RESIDENTIAL BUILDING PERMIT APPLICATION

Street Address: 1212 CARTLEY COURT
City: WOODBINE State: MD Zip Code: 21797
Subdivision/Village/Complex Name: LISBON ACRES
Lot: 21 Tax Map: 0008 Parcel: 0351

Existing Use: RESIDENTIAL SFD Proposed Use: DETACHED GARAGE Estimated Cost: \$ 60,000.00
Trade Work to Be Completed (Separate Permits Required): Mechanical (HVACR) Electrical Plumbing None
Construct 30' X 40' Detached Garage

From: Oswald, Hank
Sent: Monday, September 18, 2023 7:57 AM
To: Joseph Rutter; David Eash
Subject: Waiver Request_1212 Cartley Court_Garage Addition

LOCATION DIAGRAM

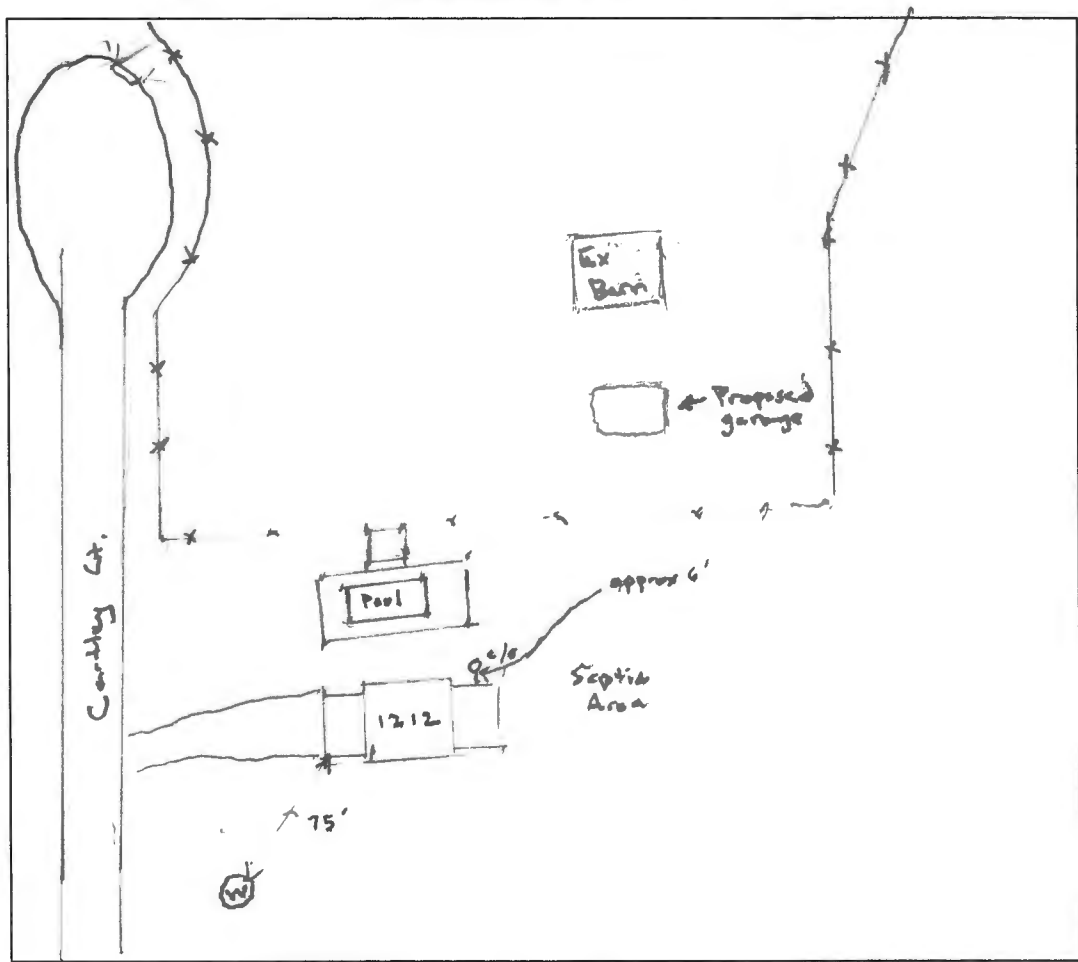
COMMENTS: Old Fred Rd
No issues observed w/ well or septic.
